Agenda Item: Public Improvement Variance – Rice Road Park

Public Improvement Variance: Variance request related to public improvements along Rice Road associated with Rice Road Park Project

Rice Road Park and Road Expansion

EXHIBIT 1

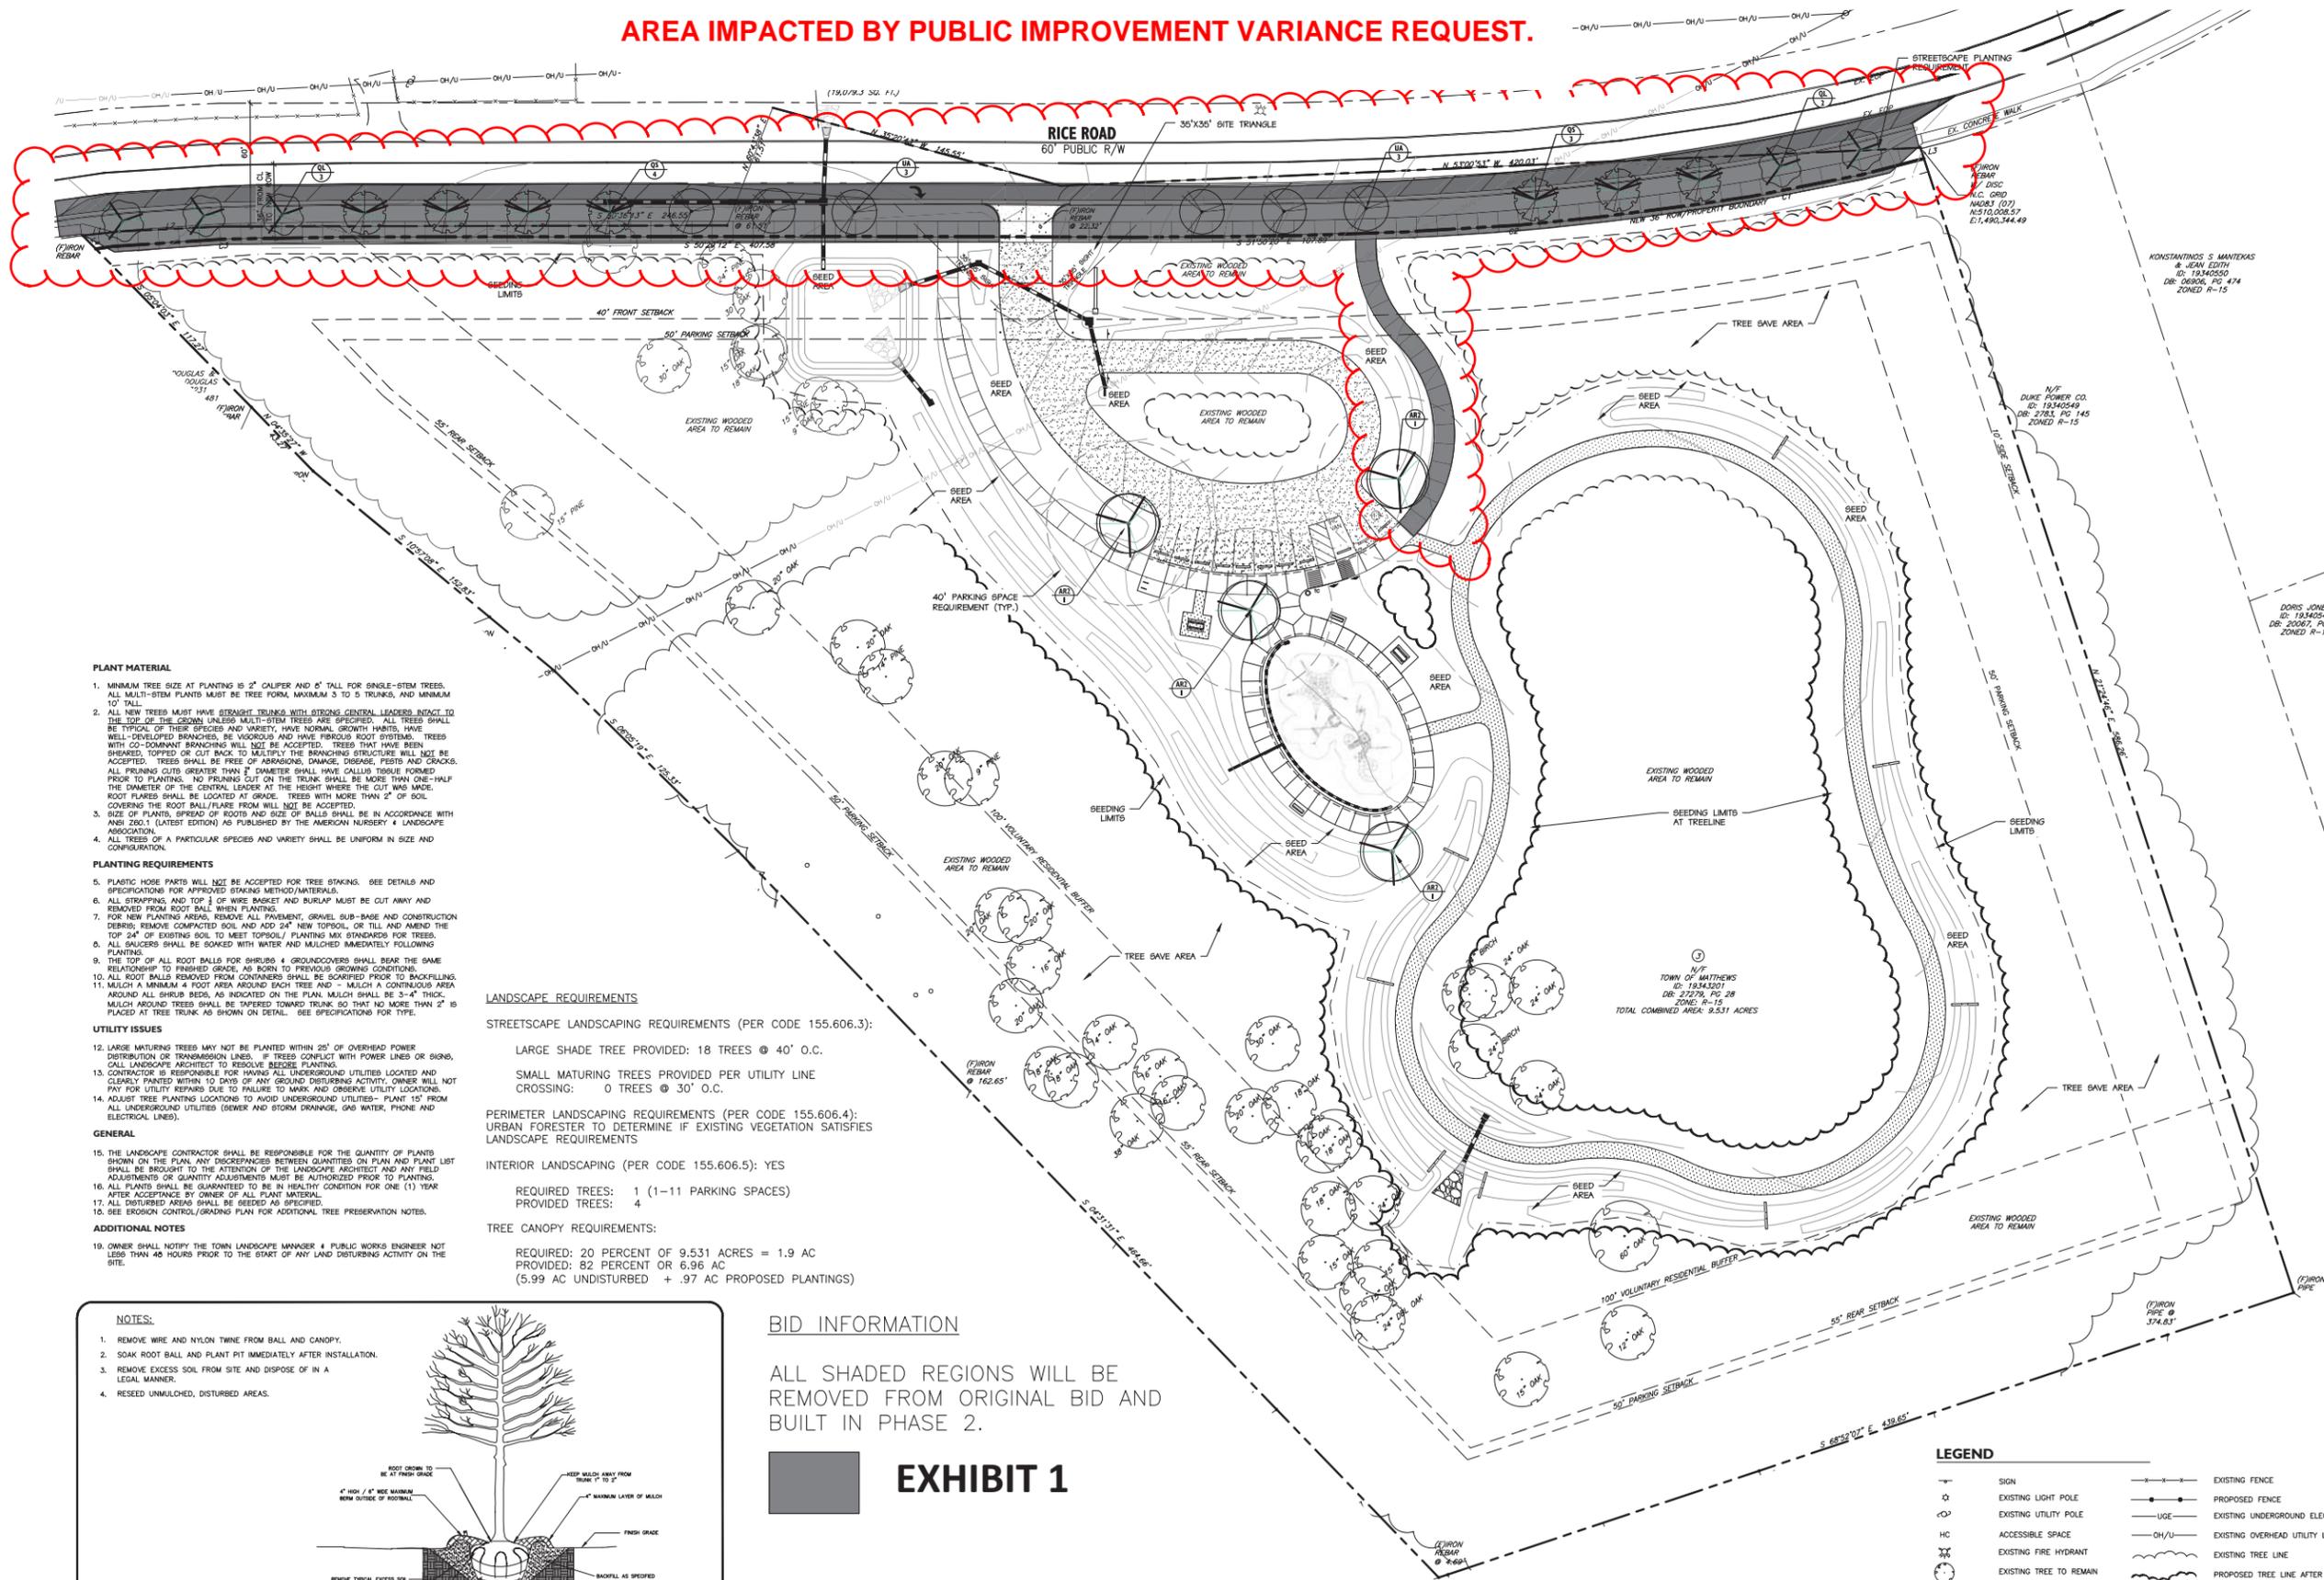
Explanation: The Parks, Recreation & Cultural Resource Department respectfully requests a public improvement variance, delaying improvements to Rice Road as part of Phase I development for this project. Improvements described include road widening, curb and gutter, and storm drain installation and widening sidewalk in the project area. The applicant requests to make these improvements part of Phase II development on the site. The project plan elements that would remain include a flared concrete apron connection to Rice Road, and the existing 5' sidewalk would remain as pedestrian access into the site. See illustrations attached.

AREA IMPACTED BY PUBLIC IMPROVEMENT VARIANCE REQUEST.

ALL SHADED REGIONS WILL BE REMOVED FROM ORIGINAL BID AND BUILT IN PHASE 2.

- ❖ Planning Board unanimously recommended approval of the Public Improvement variance request with the condition that funding for these improvements be secured within 24 months.

Staff recommends Town Board approve the Public Improvement Variances as submitted.
